# **Technical Memorandum 5 – Part 2:** **Sustainability of Basin Optimization Scenarios** *Groundwater Sustainability Plan for the Spadra Basin*

Project No. 954-80-20-01

Appendix A. Comments and Responses on Draft Technical Memorandum 5 – Part 1
Appendix B. Cost Model for the Baseline Scenario
Appendix C. Cost Model for the Basin Optimization Scenarios 1, 2, and 3
Appendix D. Comments and Responses of Draft Technical Memorandum 5 – Part 2

**Figure 2-1**

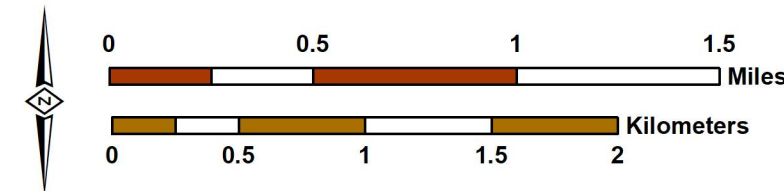
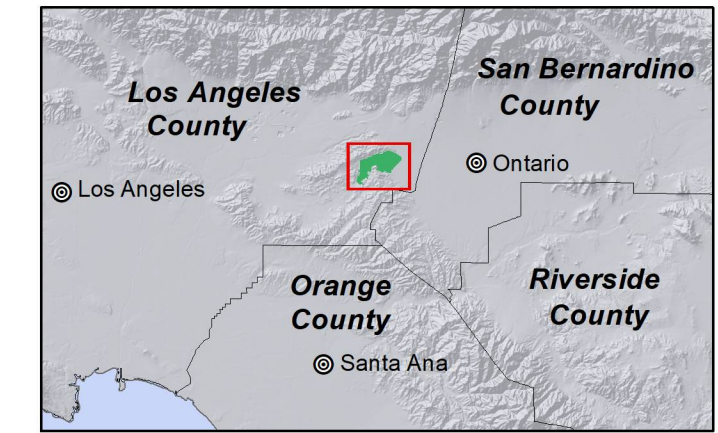
**Comment No. 3** Figure 2-1 Location Map of Proposed New Projects for the Spadra Basin (pp 9) and Figure 2-2 Location Map of Wells and Facilities for Basin Optimization Scenarios (pp 11).

**Response to Comment #3.** Thank you for providing guidance on the types of biological resources monitoring that may be necessary pursuant to CEQA. The projects implemented for the Spadra

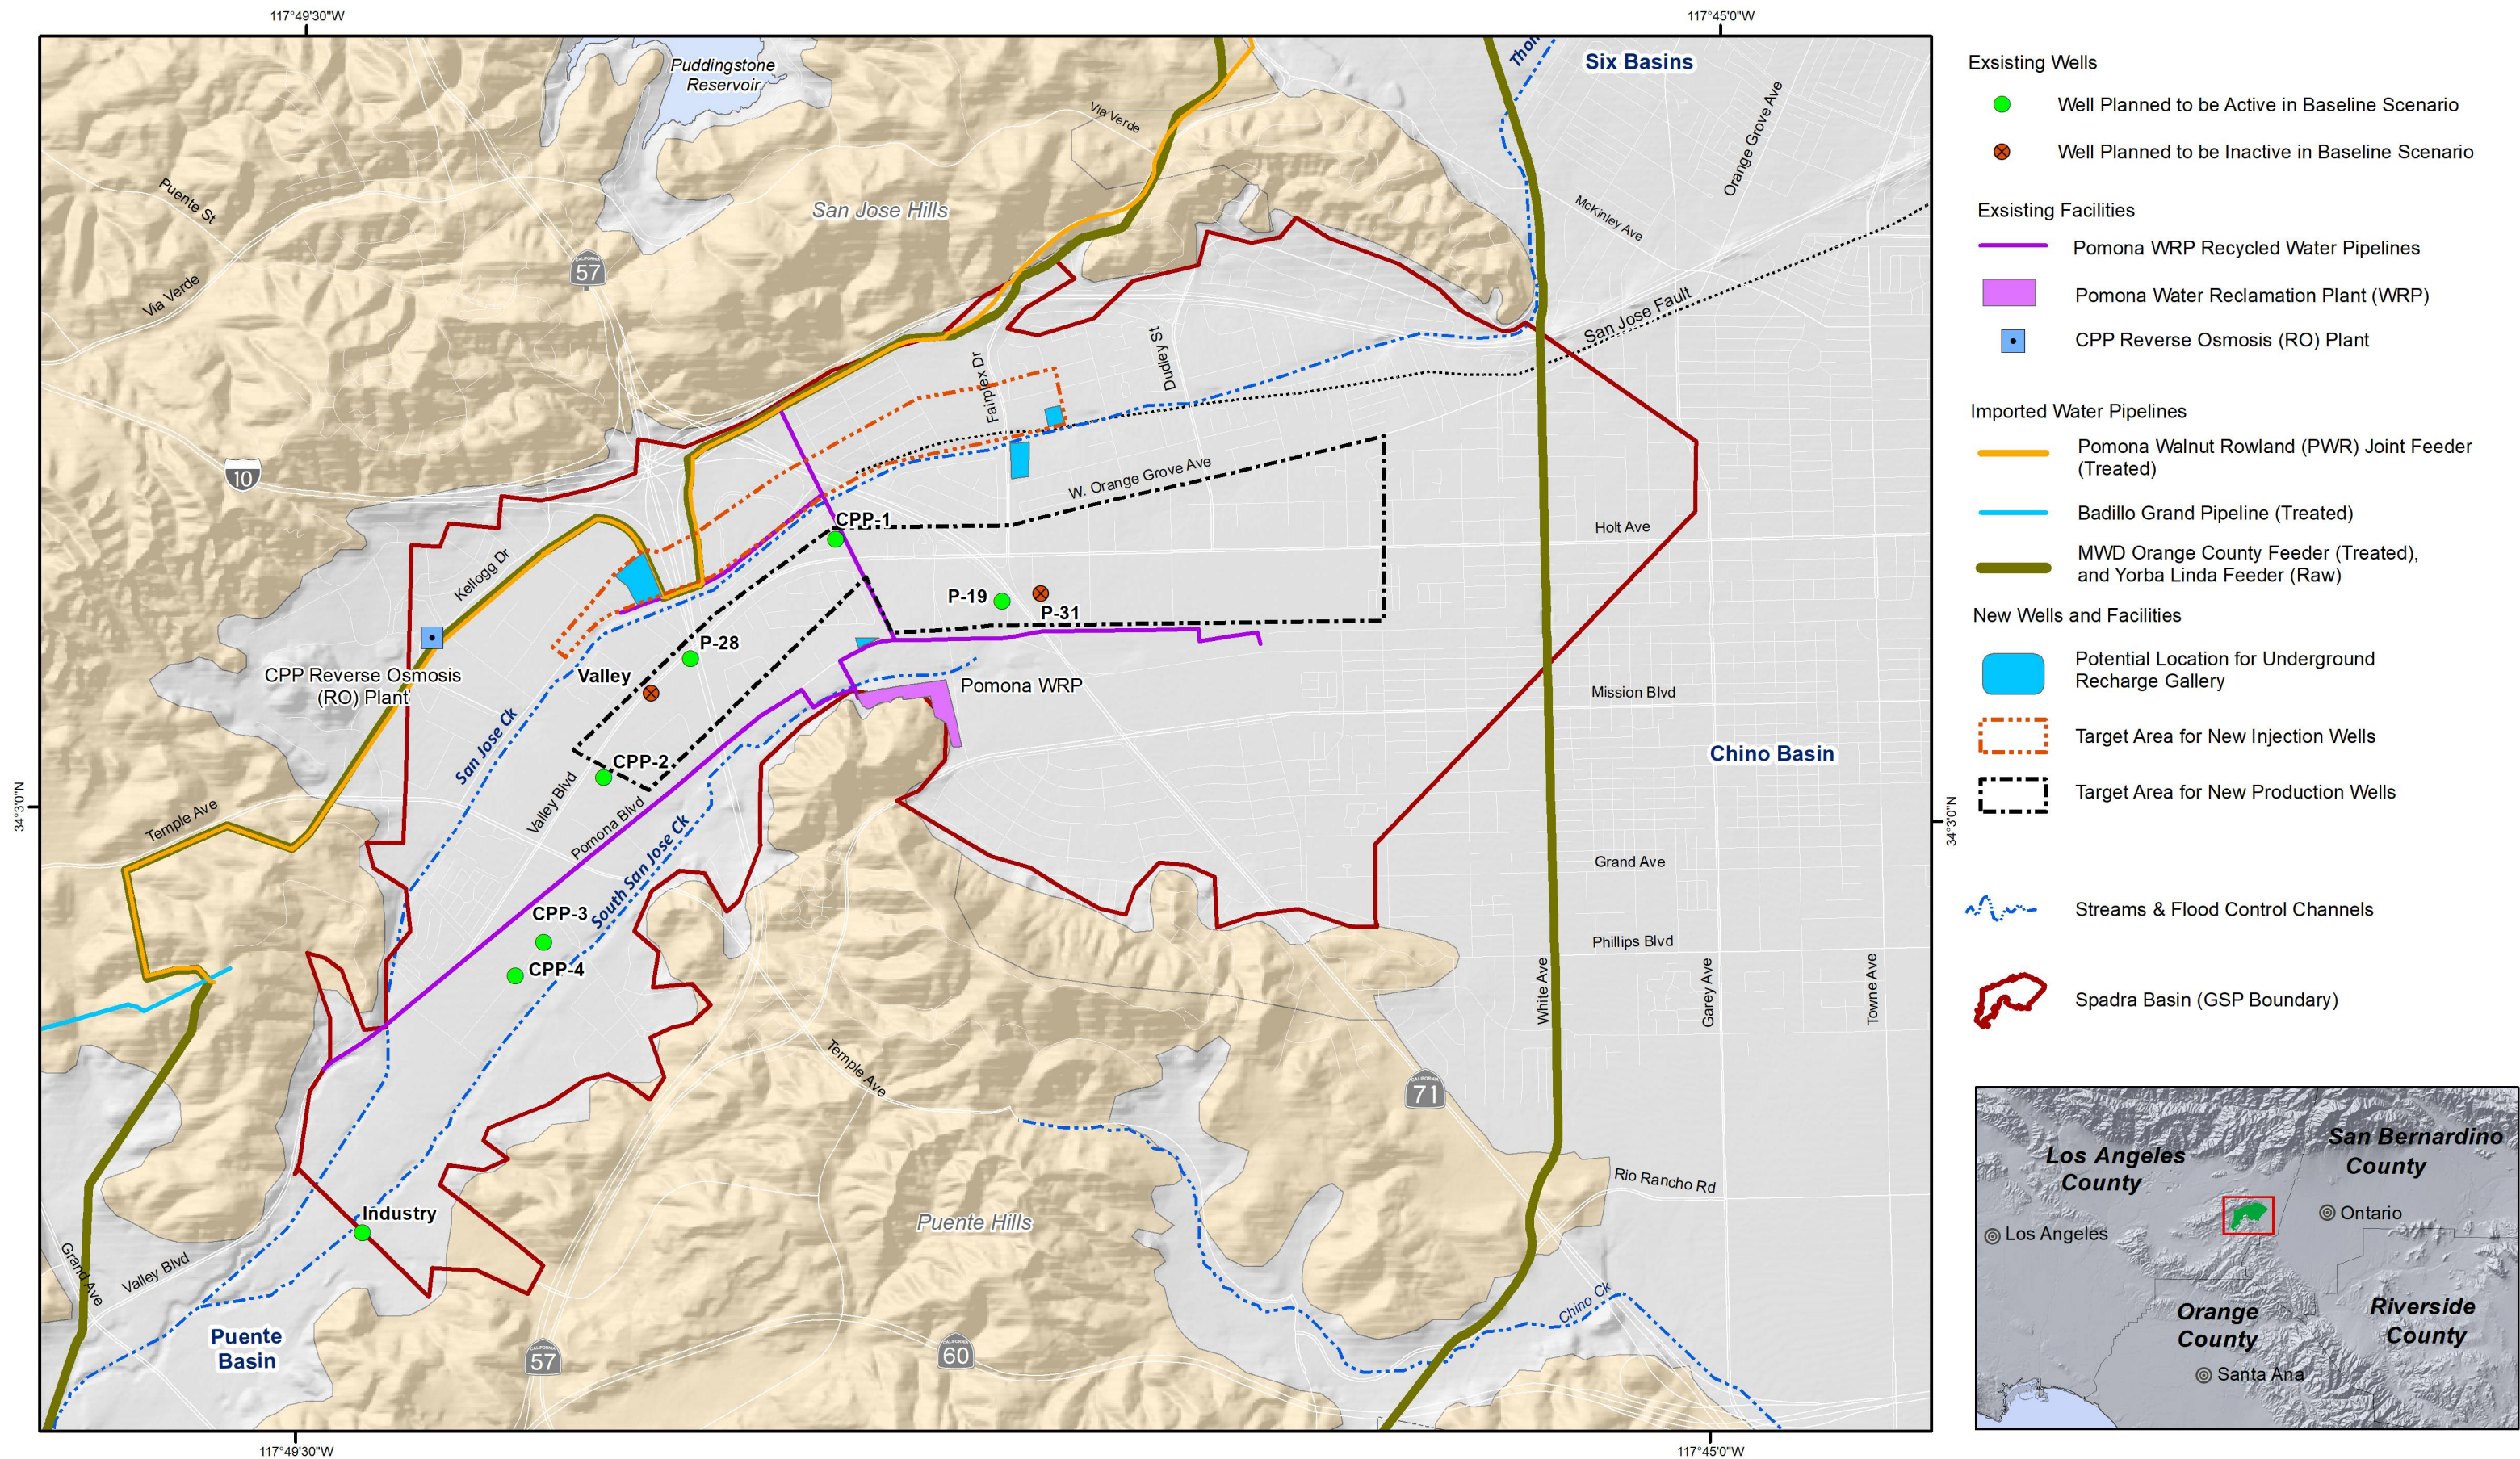
Issue: According to Figure 2-2, there are several potential locations sited for underground recharge galleries in the northern part of the basin. While these locations were identified because they are along and/or near the main Pomona WRP pipeline, CDFW is concerned about the construction activities associated with these new facilities and their impacts on wildlife. A search of the California Natural Diversity Database (CNDDDB) indicates several occurrences of merlin (*Falco columbarius*) on site and within the vicinity of the western most recharge gallery. Raptors, such as merlins, are protected under Fish and Game Code section 3503.5. Construction activities may disturb the foraging habitat of over-wintering individuals in the area. According to Figure 2-1, the area sited for a recharge gallery is adjacent to or potentially overlapping agricultural land, which is the foraging area for merlins. In addition to merlins, a rare plant was recorded in the vicinity of the western gallery location. The San Bernardino aster (*Symphyotrichum defoliatum*) has a California Rare Plant Rank (CRPR) ranking of 1B.2. Plants with a CRPR of 1B.2 are rare, threatened, or endangered in California and elsewhere (CNPS 2020). CNDDDB also indicated the occurrences of several other species near the eastern galleries. The species found in this area include, southern California legless lizard (*Anniella stebbinsi*), western yellow bat (*Lasiurus xanthinus*), and big free-tailed bat (*Nyctinomops macrotis*), all of which are considered California Species of Special Concern (SSC)
